Re: Fairfield Townhomes – Site Plan and Subdivision Plat
Application Number: DA-1556-25
Case Numbers: 2022-4012-00; 2022-3018-00

Technical Corrections Review

FAIRFIELD TOWNHOMES | SITE PLAN

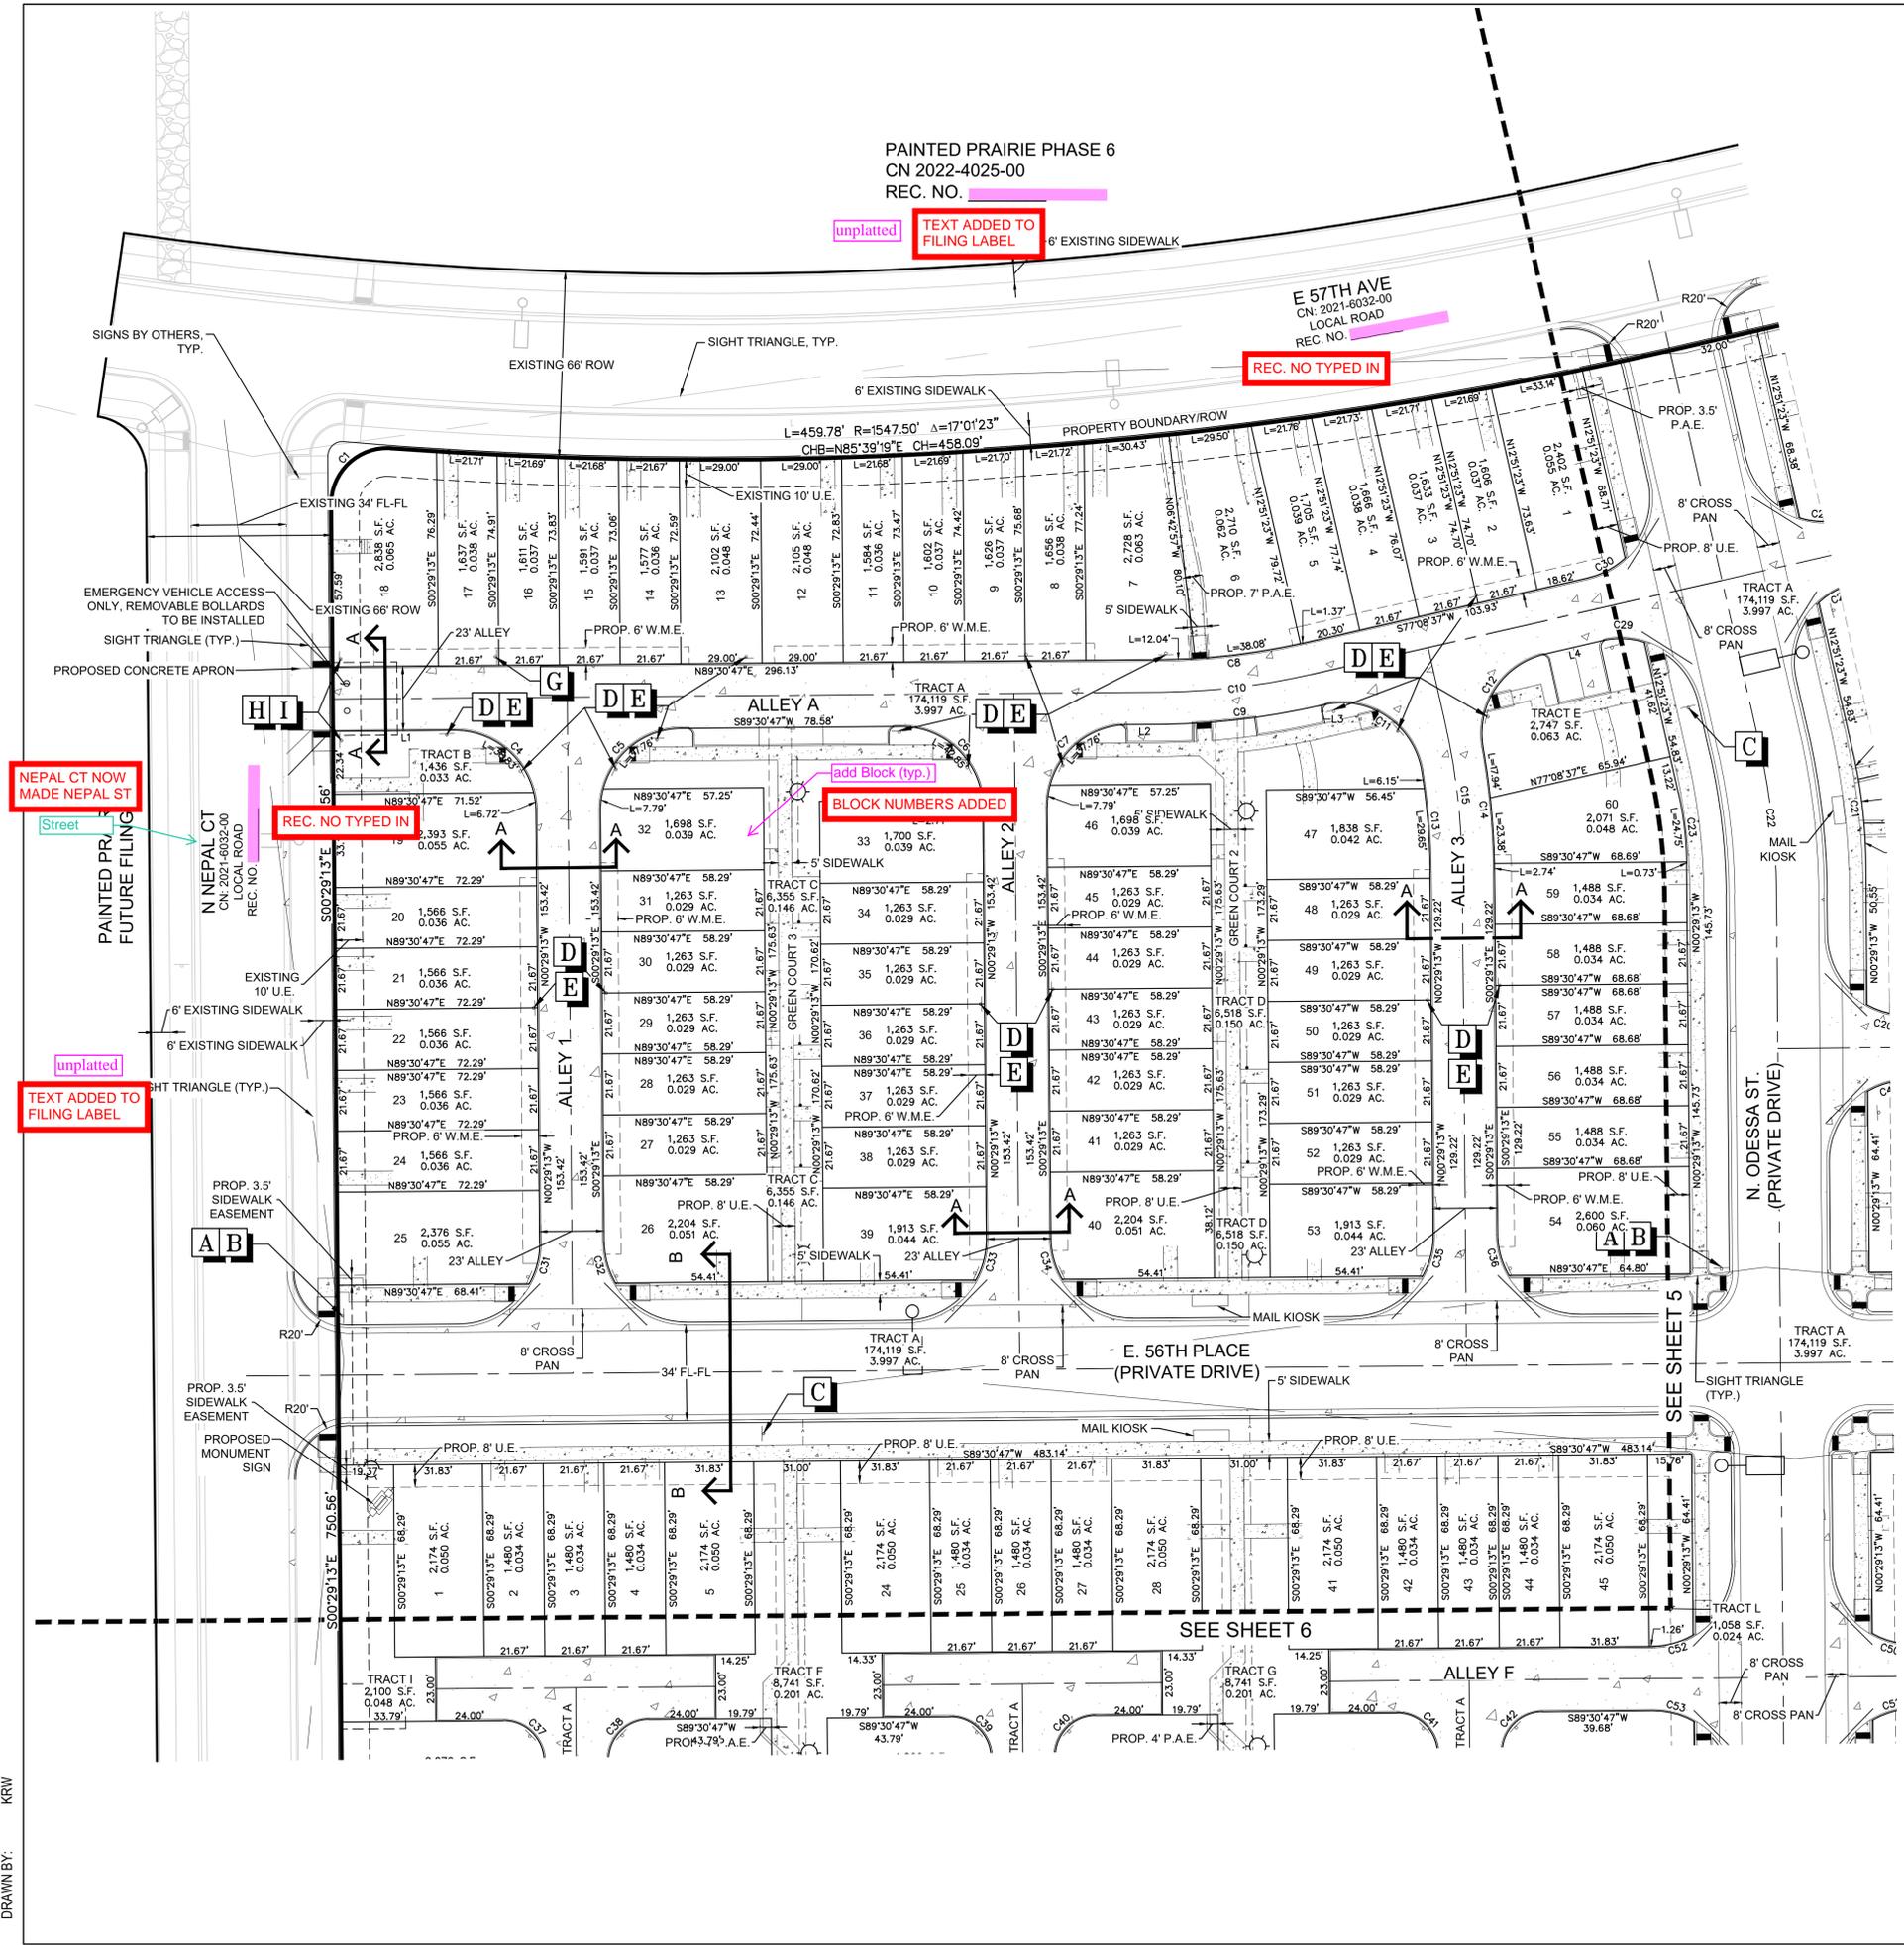
Remove note #4

Add these notes:

Response: Note has been removed.

Response: Note has been added.

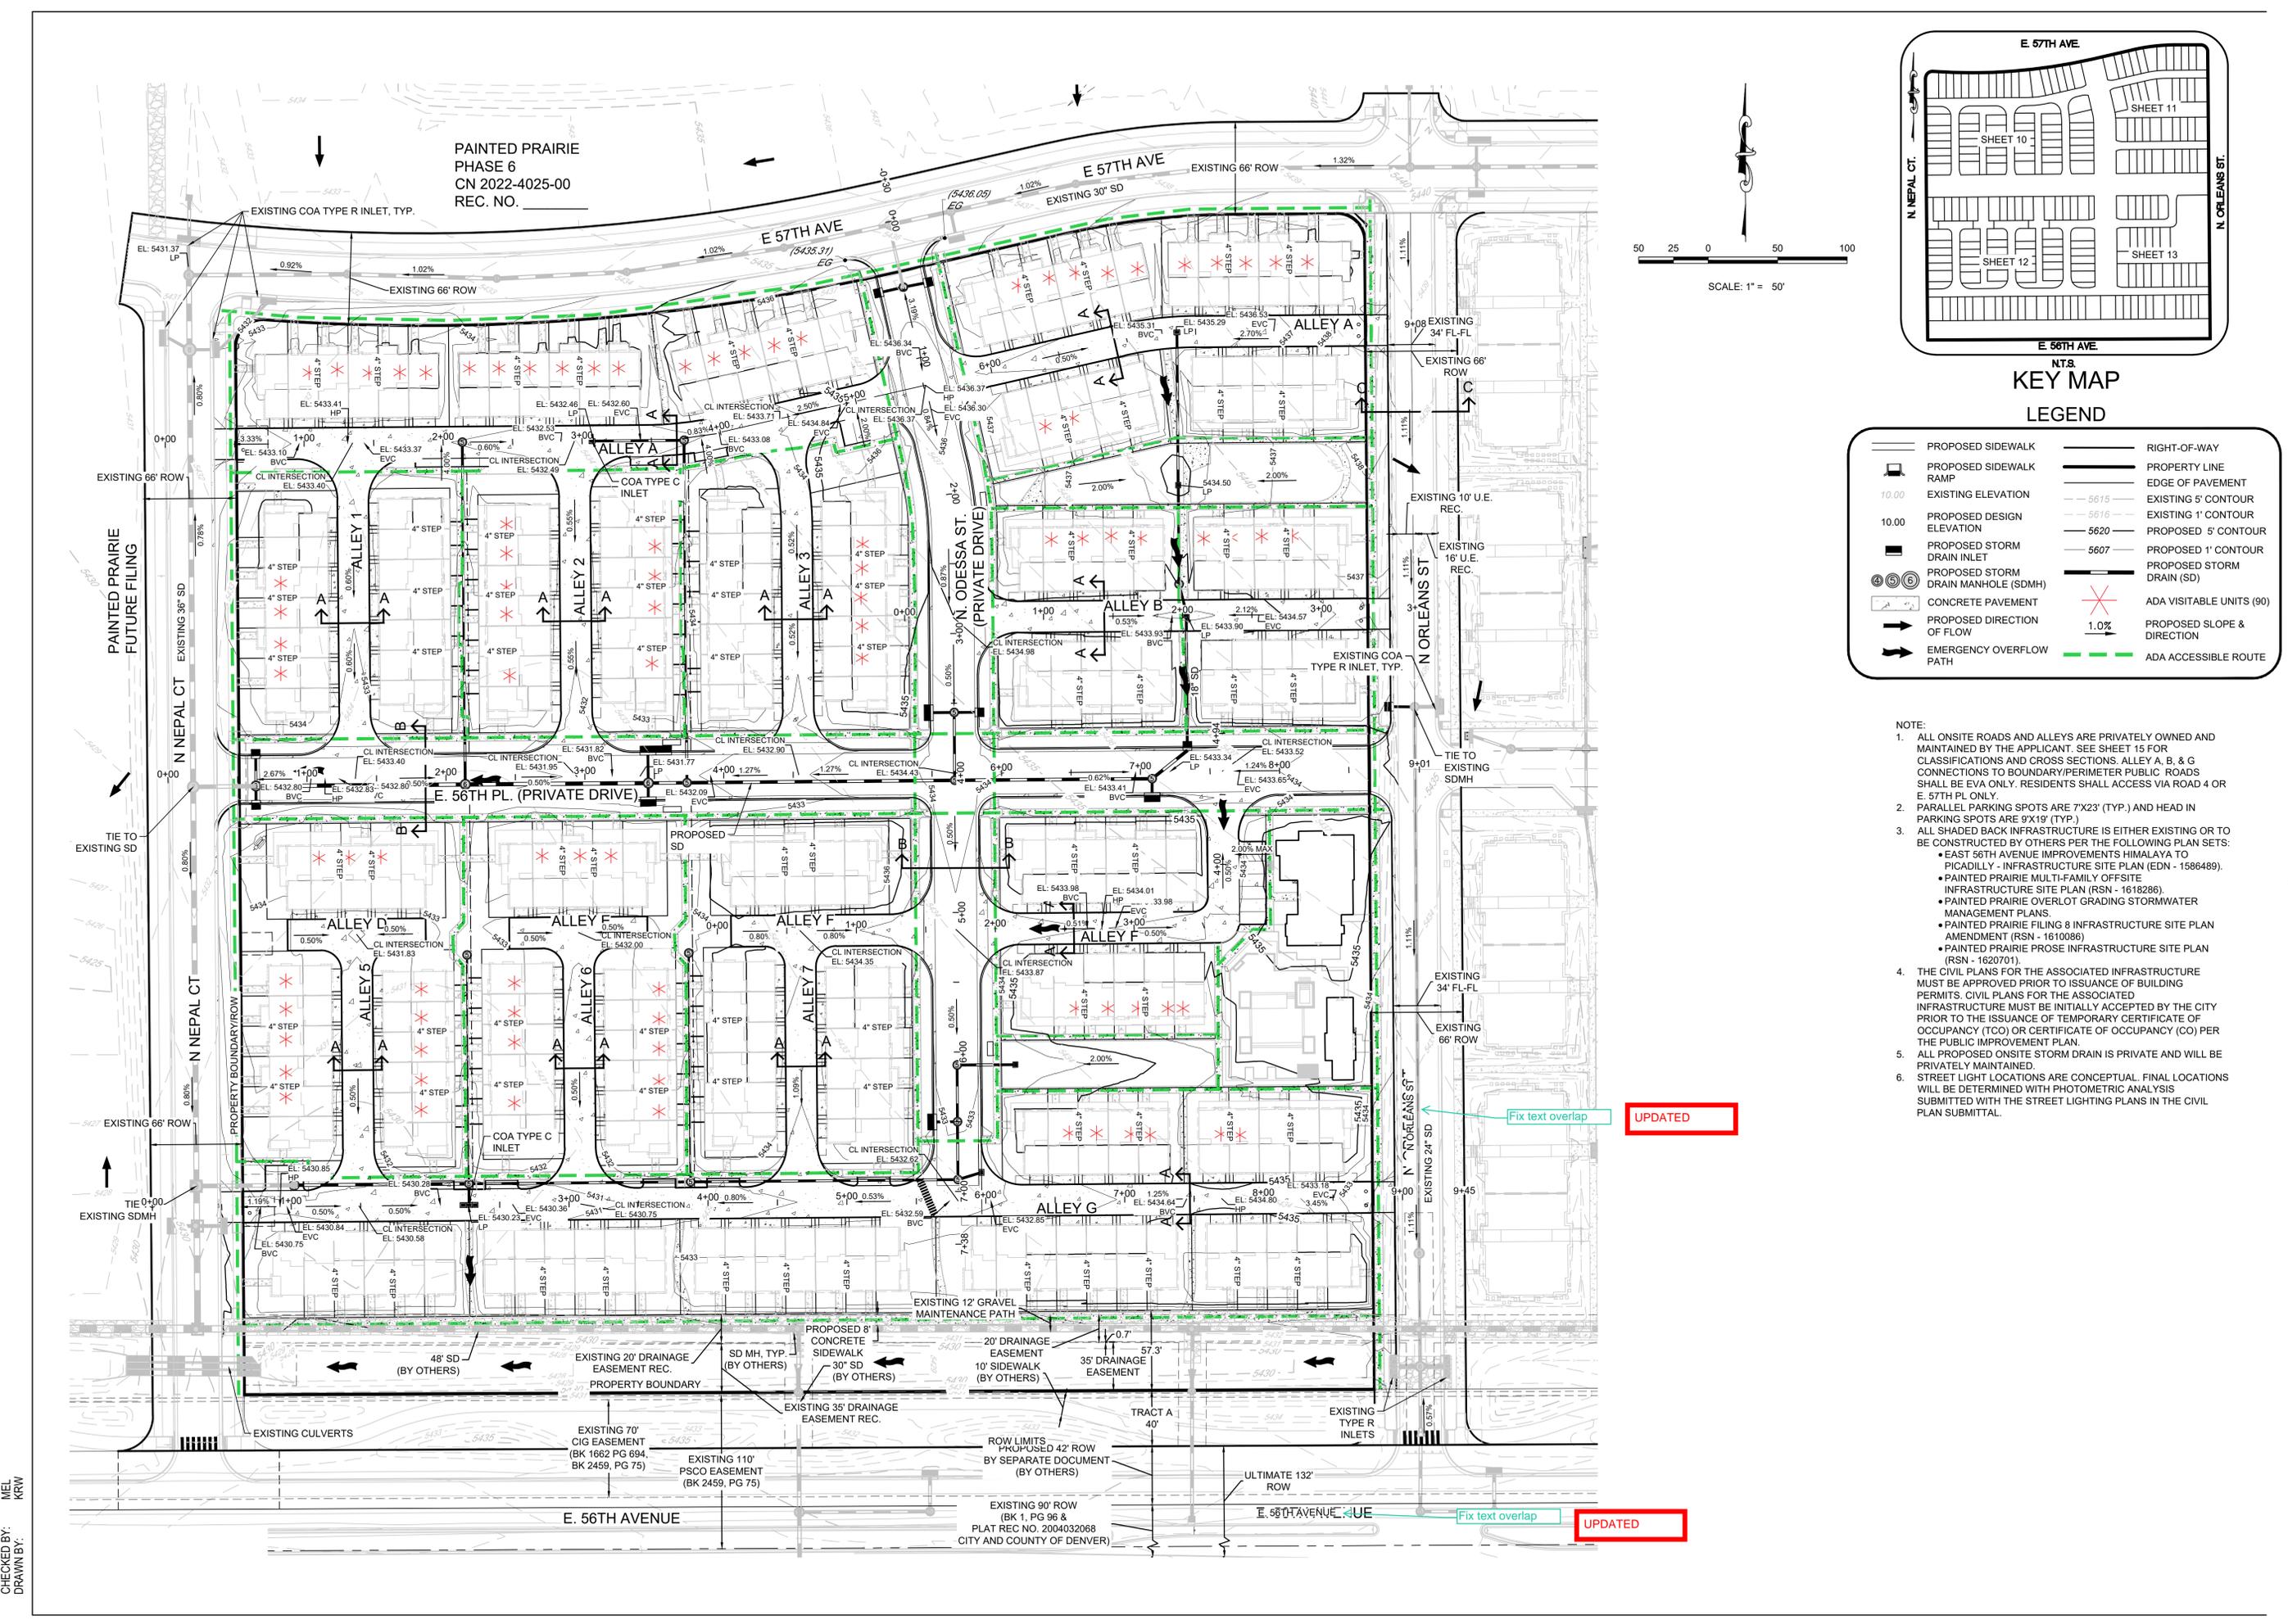
Fix text overlap

Fix text overlap

UPDATED

UPDATED

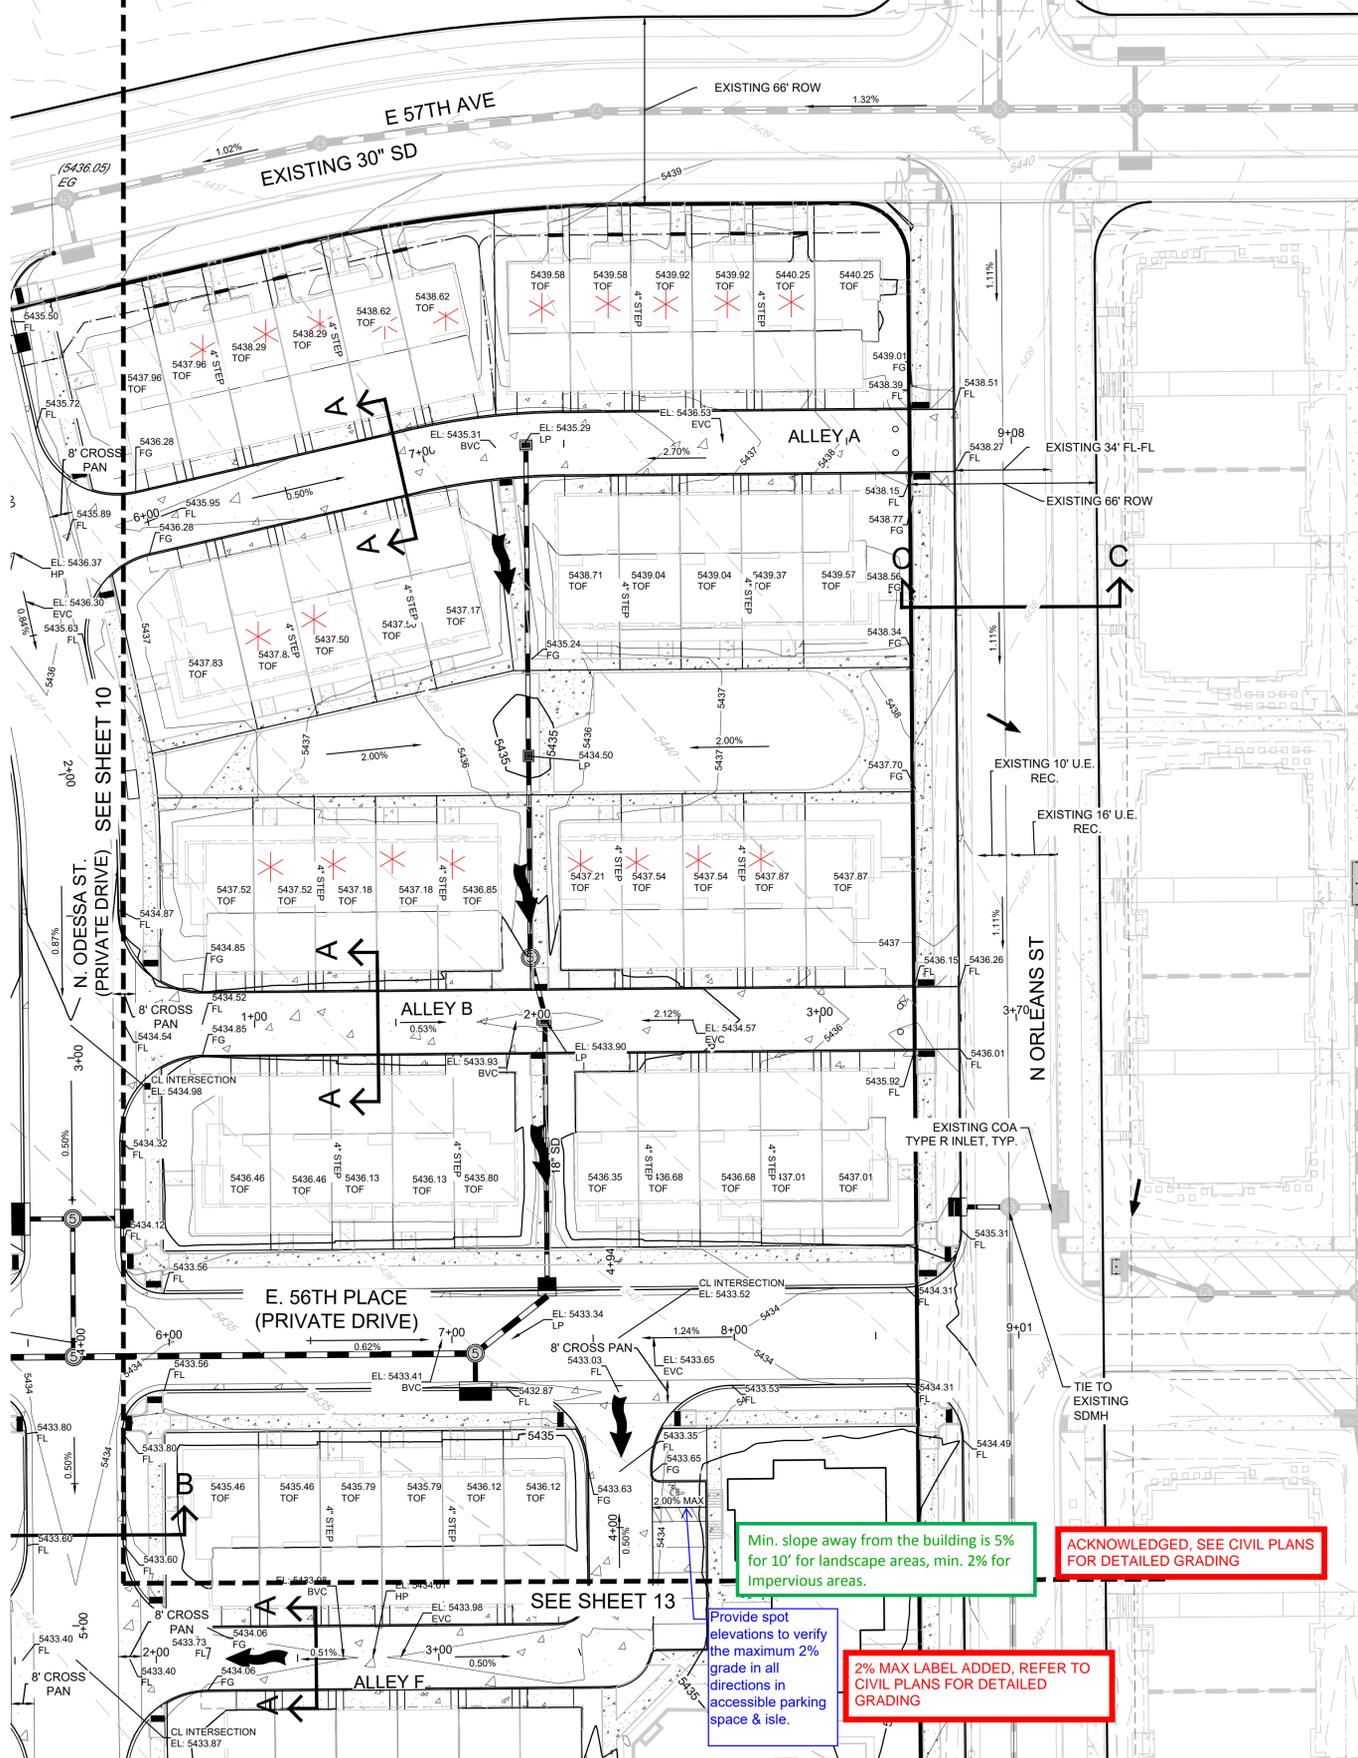
Provide spot elevations to verify the maximum 2% grade in all directions in accessible parking space & isle.

ACKNOWLEDGED, SEE CIVIL PLANS FOR DETAILED GRADING

2% MAX LABEL ADDED, REFER TO CIVIL PLANS FOR DETAILED GRADING
